ECE/TRANS/WP.29/2009/108  
27 July 2009

Proposal for Corrigendum 3 to Revision 3 to Regulation No. 12  
(Steering wheel)

Submitted by the Working Party on Passive Safety \*/

"Annex 4  
BODY BLOCK

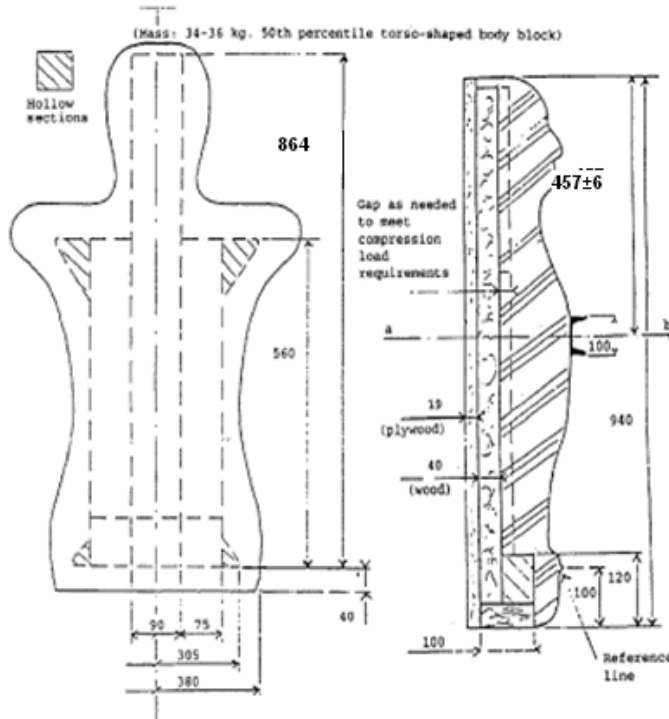
Annex 4, appendix, amend to read:

Spring rate: 107 - 143 kgf/cm.  
The chest is loaded with .....

"Annex 4  
BODY BLOCK

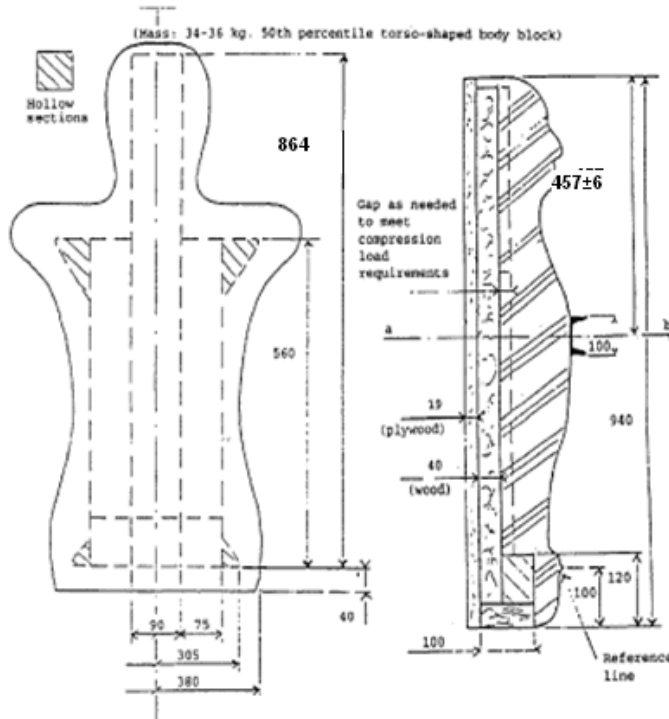
Annex 4, appendix, amend to read:

Spring rate: 107 - 143 kgf/cm.  
The chest is loaded with .....
